Knockcronal Wind Farm

Gatecheck Report

Client: Statkraft
Project/Proposal No: 3206
Version: V3
Date: 2021-05-27

Figure 10a
Layout V and On Site Constraints
- Turbine Development Area

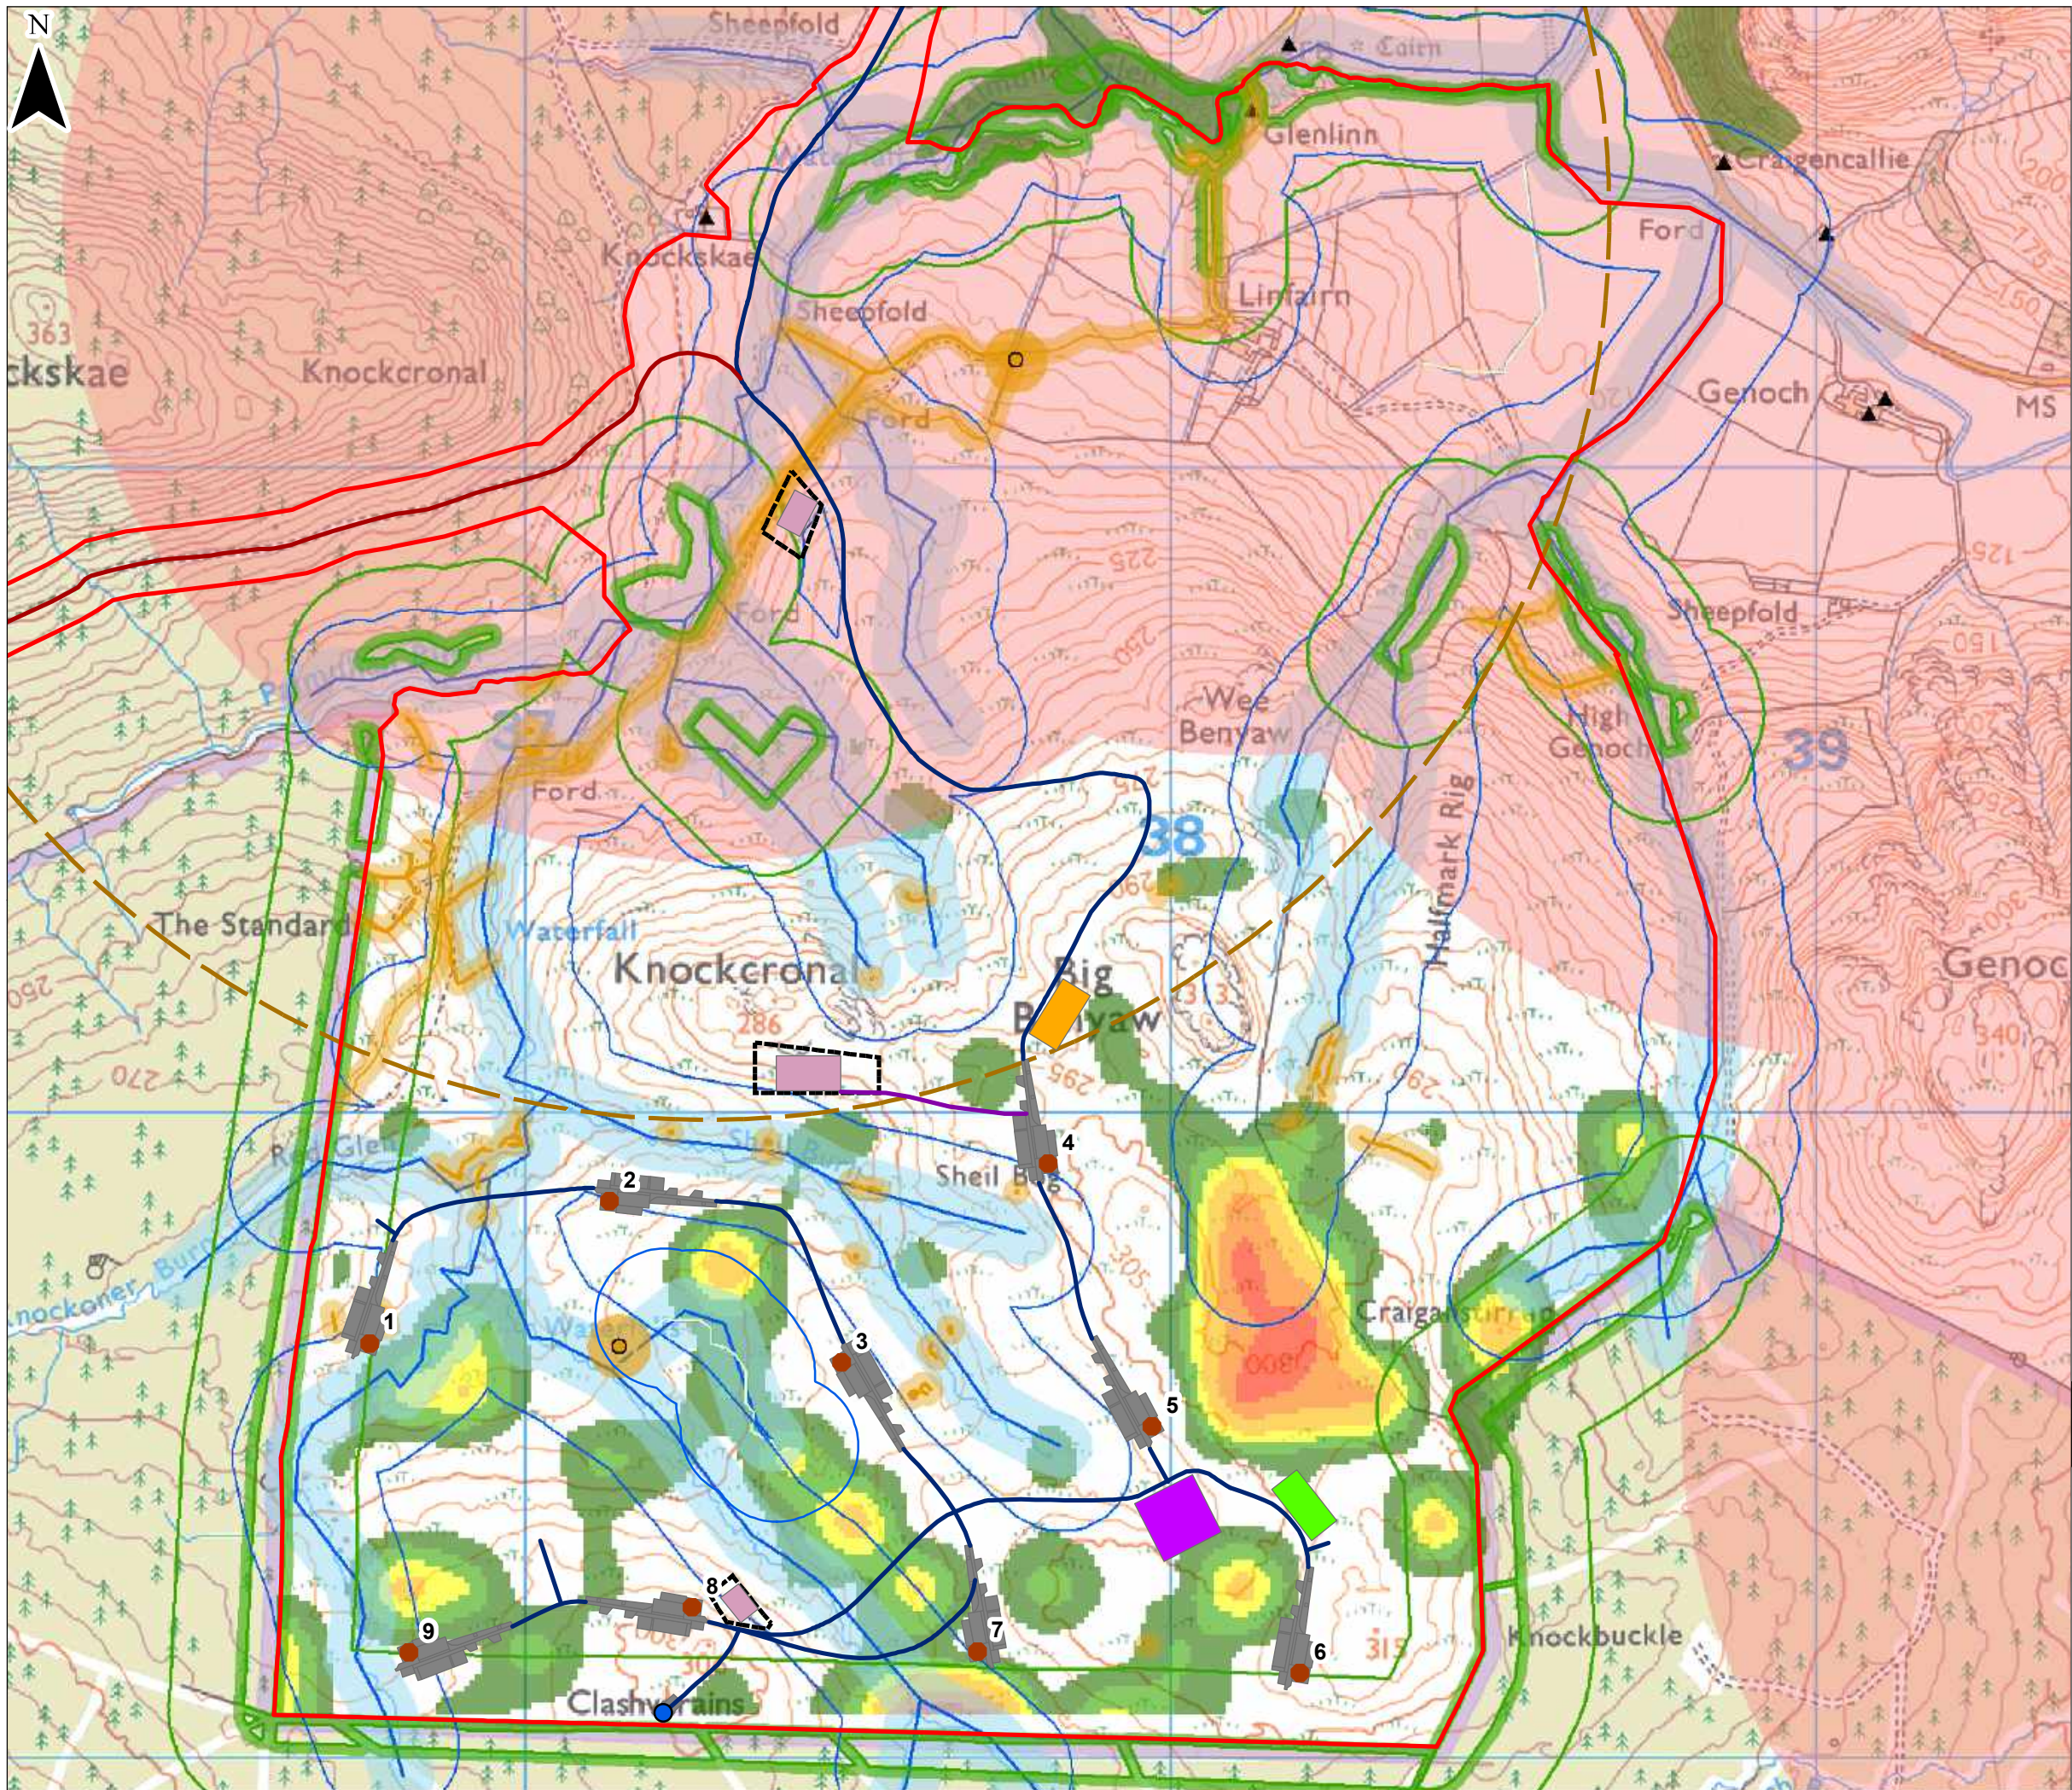
Since the submission of the EIA Scoping Report and the receipt of the EIA Scoping Opinion the Applicant has undertaken design iterations to maximise the capacity of the Proposed Development while minimising the environmental impacts. The main iterations are described below and shown on Figures 2 to 9. These iterations have taken into consideration the existing tracks and on-site environmental and engineering constraints, including avoidance and/or appropriate buffering of watercourses and sensitive habitats (refer to Figure 10a and b).
